## **URGENT MODIFICATION CONSULTATION DOCUMENT 2**

**MODIFICATION PROPOSAL P18**

**Removing/Mitigating the Effect of System  
Balancing Actions in the Imbalance Price  
Calculations**

**Prepared by ELEXON on behalf of the Pricing  
Issues Modification Group**

Period Average

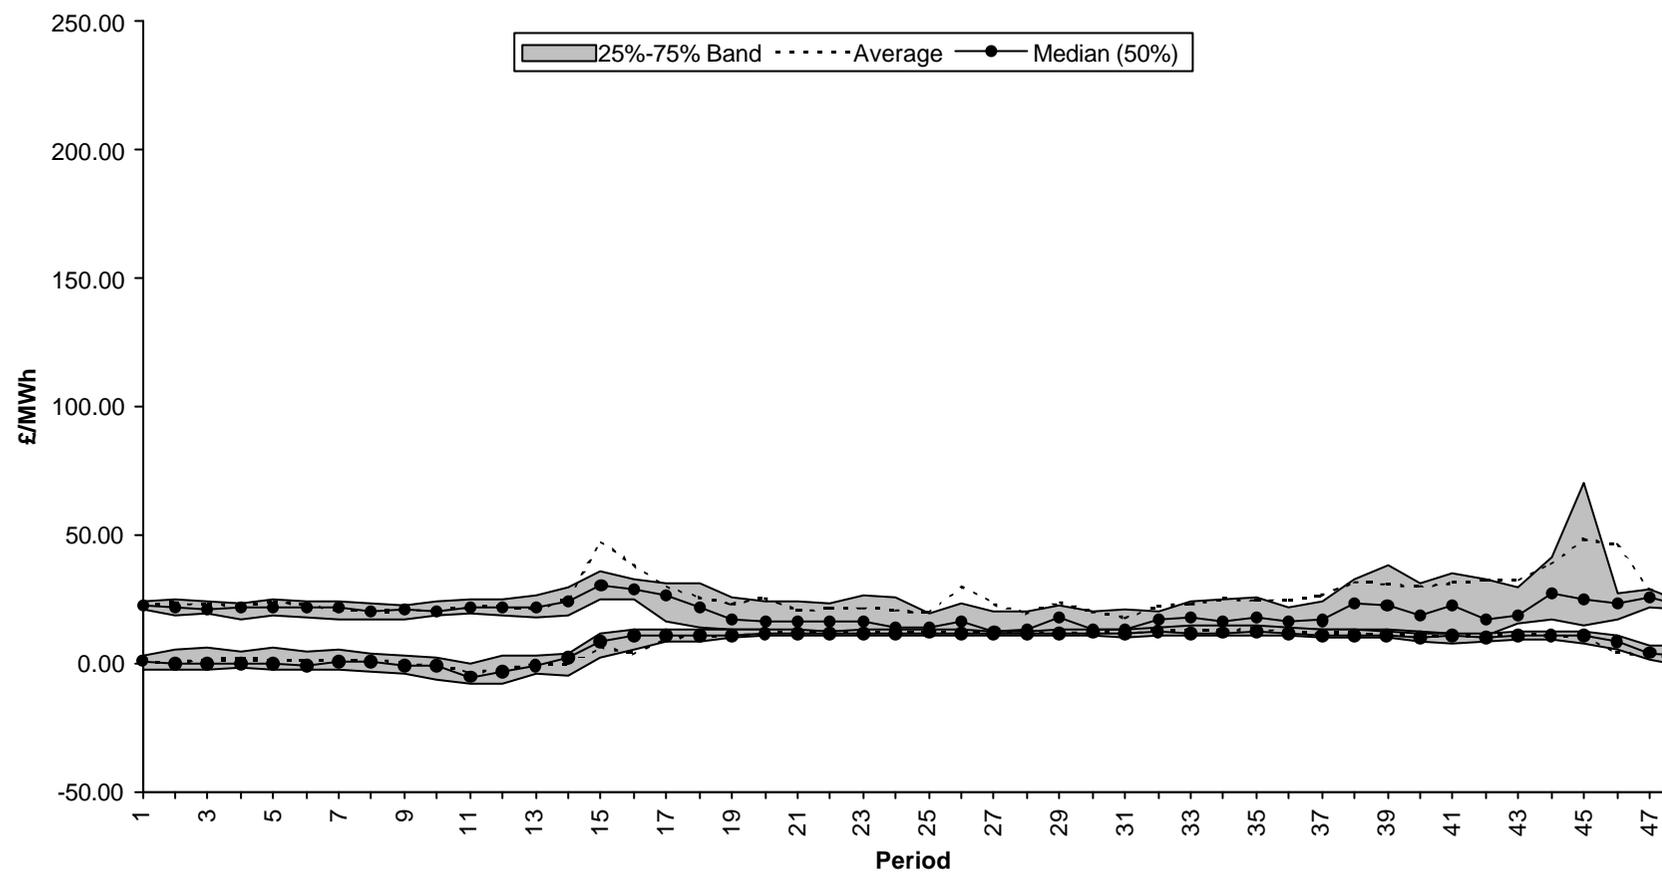
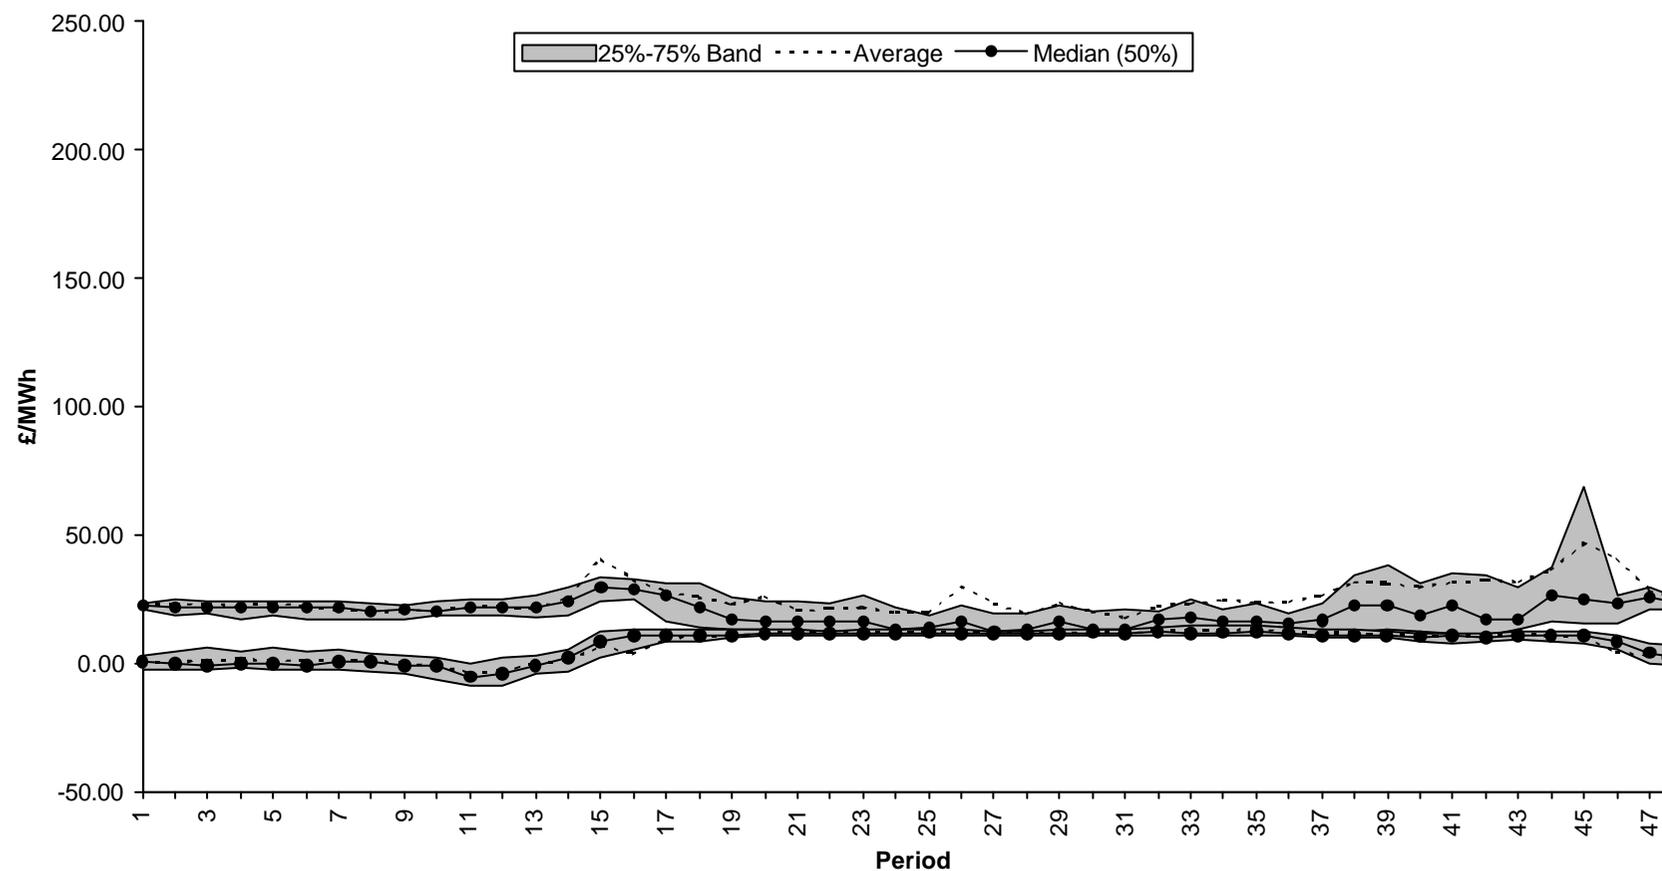
**Discussions in the Modification Group noted that as CID was increased, the "spikiness" of the data, particularly around period 14 reduced, clearly indicating the extreme values of System Buy Prices and System Sell Prices were being removed.**

**However, with larger values of CID the range of prices in periods 39-45 were also significantly dampened.**

- **A CID of 15 minutes would not remove all spikes;**
- **A CID of 30 minutes will flatten the evening peak;**
- **CID should not, in any event, be set to be greater than 30 minutes (i.e.  $CID_{max} = 30$  minutes)**
- **Some prices can increase (although this is unusual, and occurs because relatively cheap offers or bids are removed);**
- **50% of periods during the day already have a price determined on a default basis;**
- **CID can increase the incidence of defaulting prices to 50% during the evening as well.**

- **Modification P18A was effective at removing short duration acceptances from the price calculations;**
- **The value of CID could be selected so as to strike a balance between removing sufficient of those acceptances deemed to “system balancing” actions, but not tagging too many acceptances deemed to be “energy balancing actions”.**
- **The view of the members of the Modification Group present on 28<sup>th</sup> June 2001 was that based on the data analysis presented, CID should be set somewhere in the range between 10 and 20 minutes.**

Graph 9 – Analysis of Default Periods

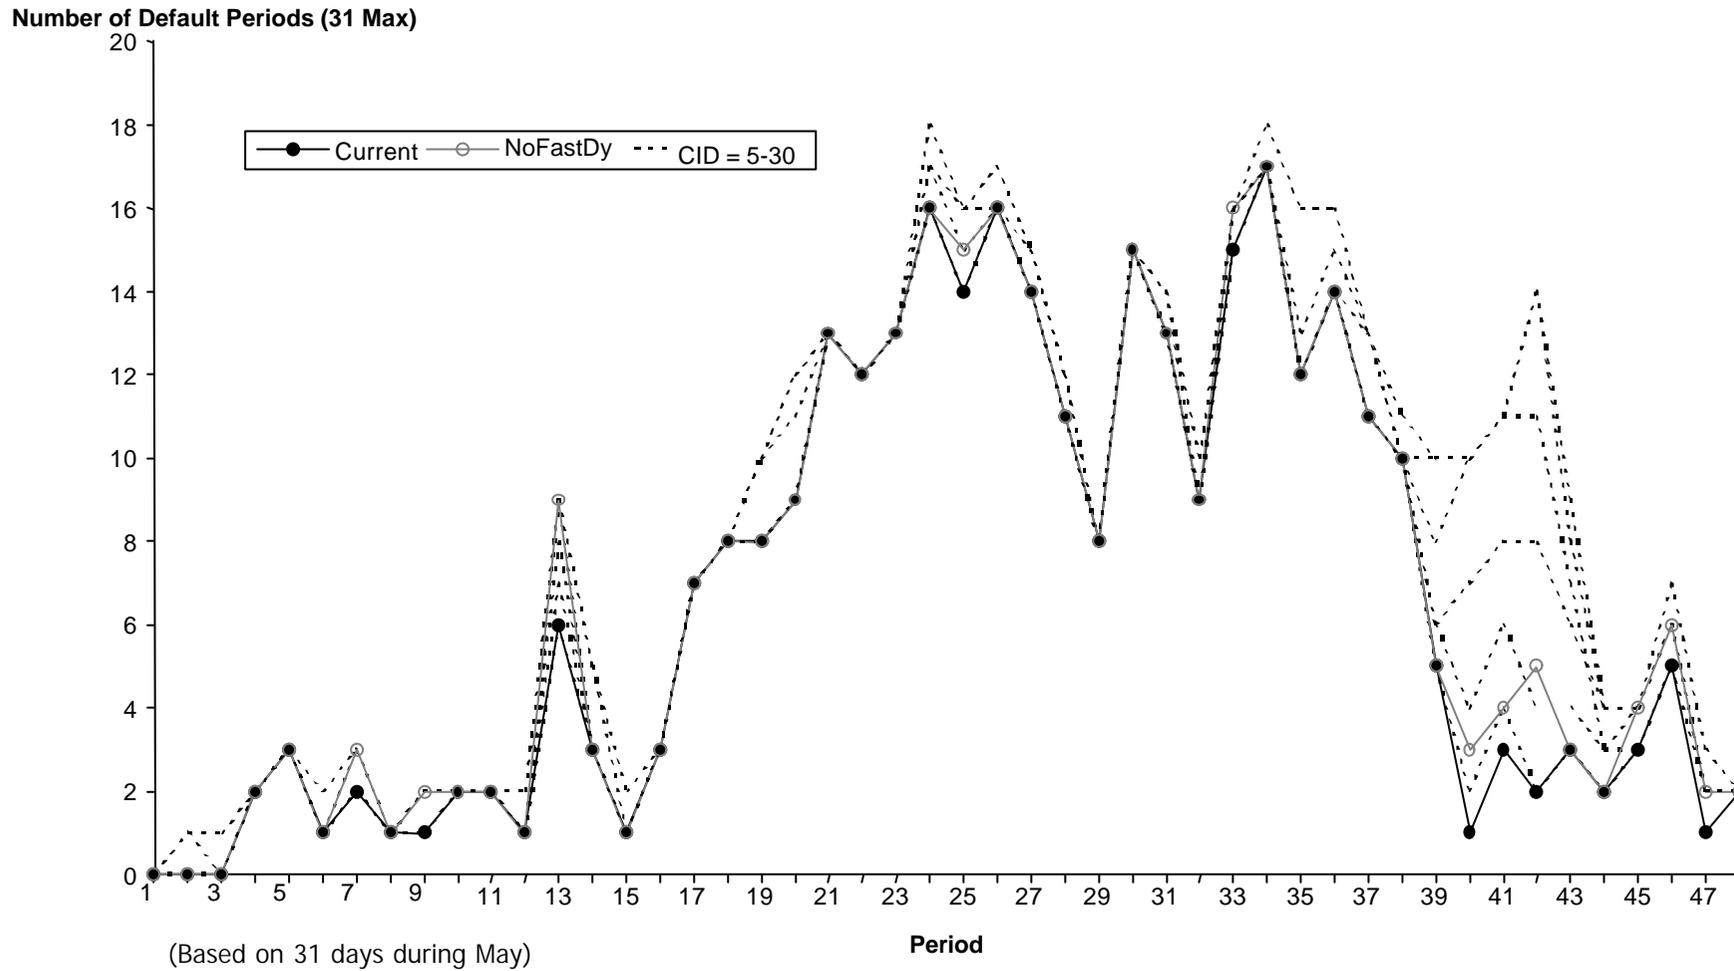
Graph 9 shows an analysis of the number of periods in which prices would be set on a default basis as the value of CID is increased. The dotted lines show the increase in the number of periods in which prices are set on a default basis as CID is increased. The effect is most marked around periods 39-45 when as CID is increased (say to 30 minutes) the middle range of the data is significantly damped. As an example, with a CID of 30 minutes, prices would be set on a default basis in this period approximately 50% of the time in period 42.

The Modification Group recognised that it was necessary to strike a balance between setting a high value of CID so as to exclude short duration acceptances, but not to set it too high such that those acceptances that should properly contribute towards the price calculations are also excluded.

Figure A – Workaround architecture 1a

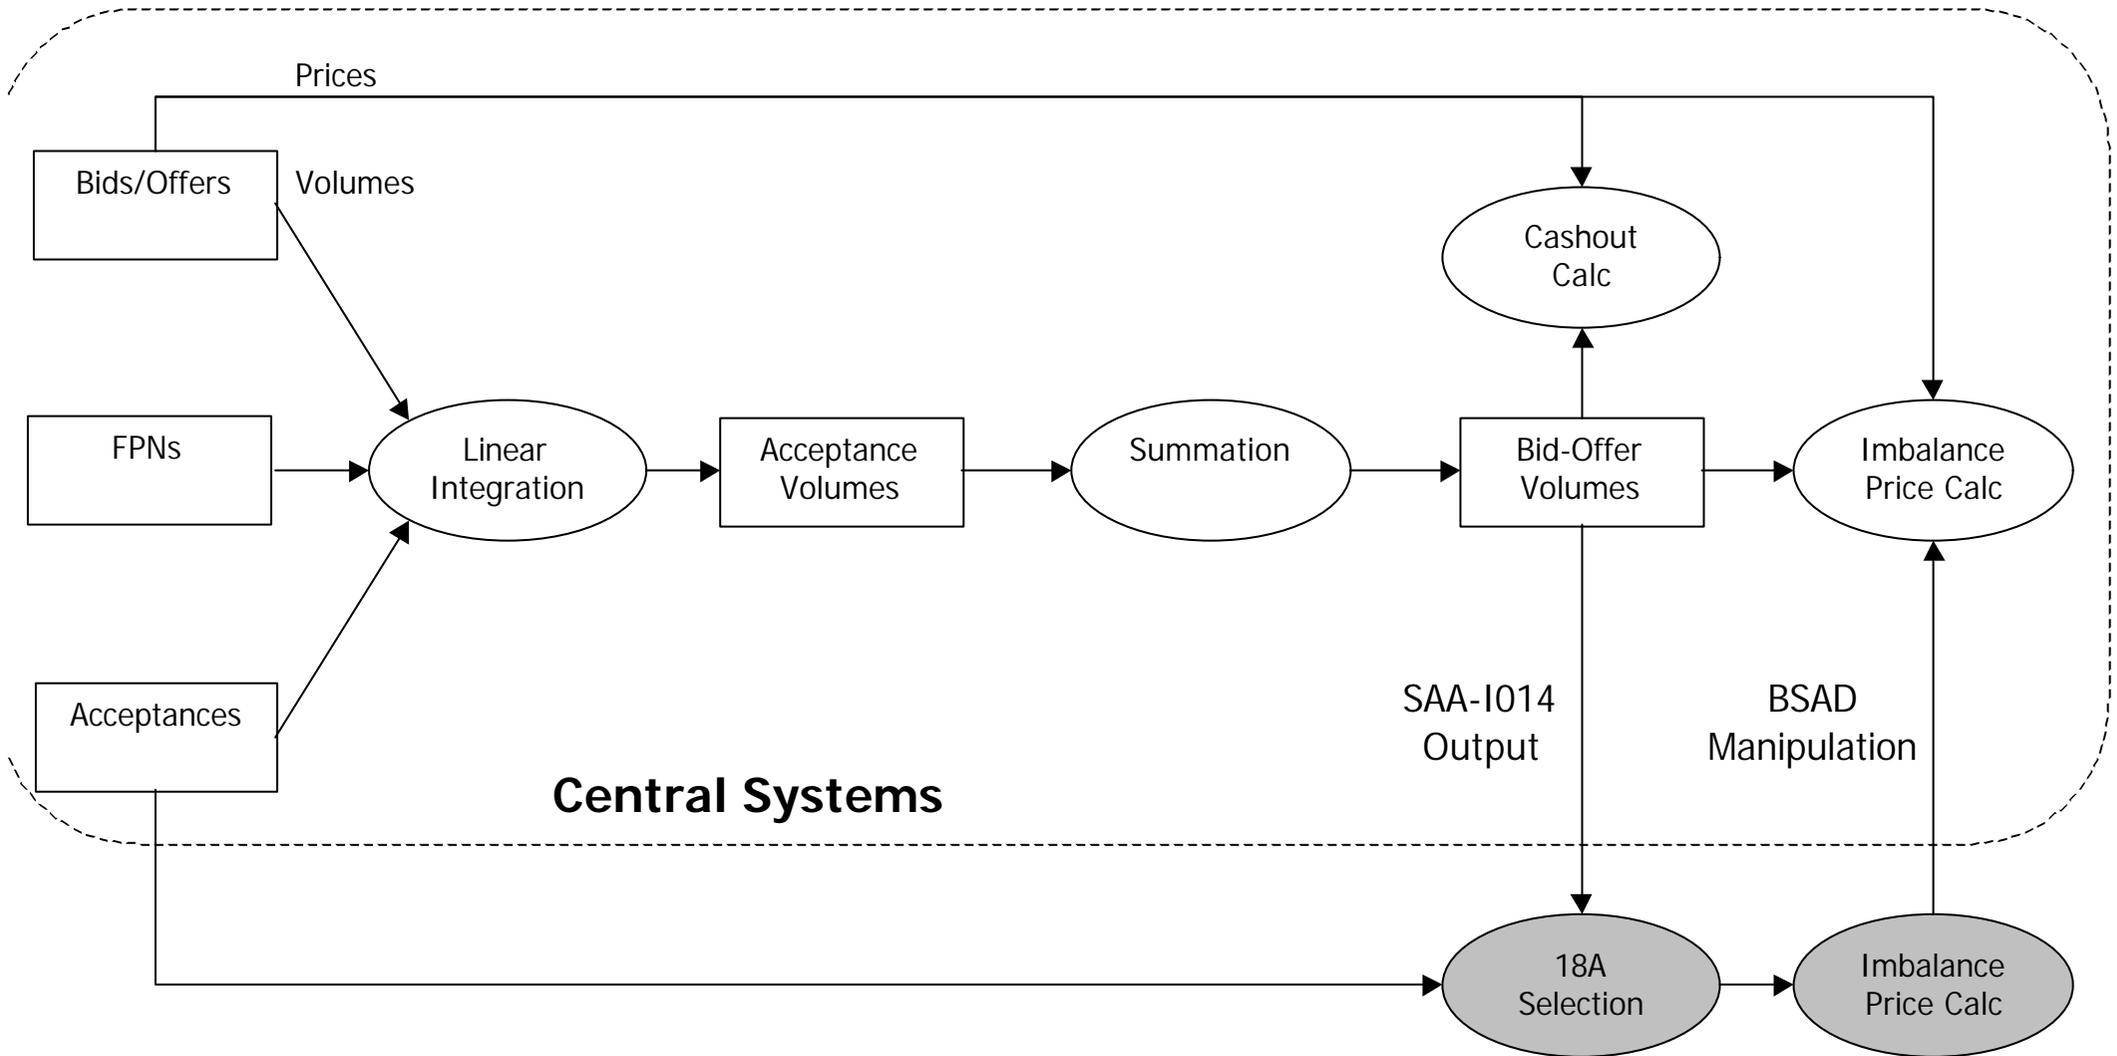
- It is reliant on an organisation (ELEXON) not structured to provide an operational service.
- This option would be utilising a system designed for post-event monitoring (the TOMAS system), as an operational system used to establish prices.

- Because this option relies upon settlement data in order to determine the revisions to be made to the BSAD data stream, the revised prices are not available until after the Interim Information Settlement Run, and are not reflected in settlement until the Initial Settlement Run (D+29 approx.)<sup>6</sup>.

**The Modification Group believed that either workaround architecture 1a or 2 should be used to support the implementation of CID-definition 1a. The choice**

Figure B – Workaround architecture 1b

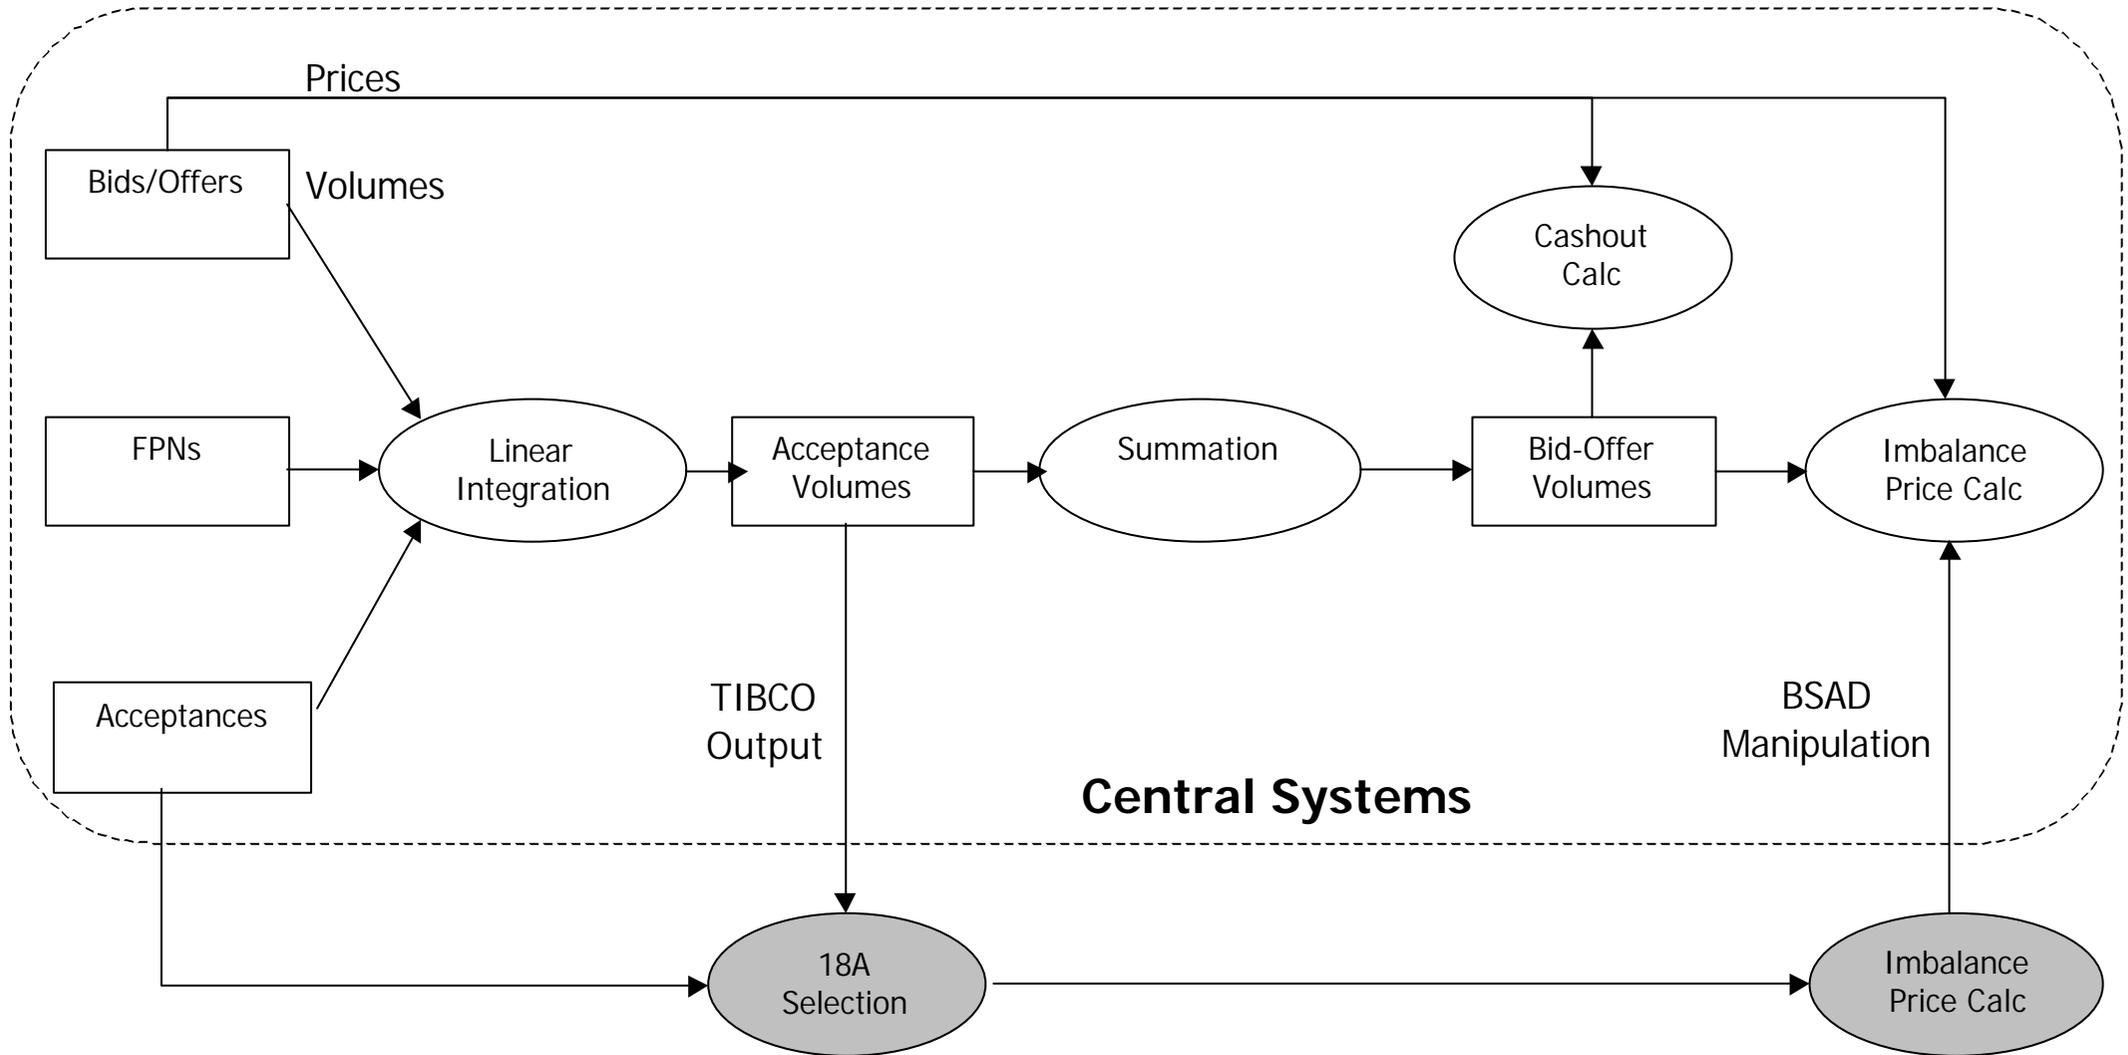
**The Modification Group did not favour this option.**

4. **Minimise errors due to communications.** Clearly the creation of additional complex and/or manual communications interfaces introduces the scope for error. If possible these should be minimised. Furthermore the provision of data from links that were not considered to have sufficient reliability is clearly undesirable. Because of the perceived risks associated with relying on the TIBCO link for settlement purposes, workaround architecture 1b was discounted by the Modification Group.

- Workaround architecture 2 may not be capable of delivery within a 3 month timescale;
- Workaround architecture option 1b is reliant on TIBCO for a data flow. This is was not considered to be sufficiently resilient for purposes of price calculations by the Modification Group;
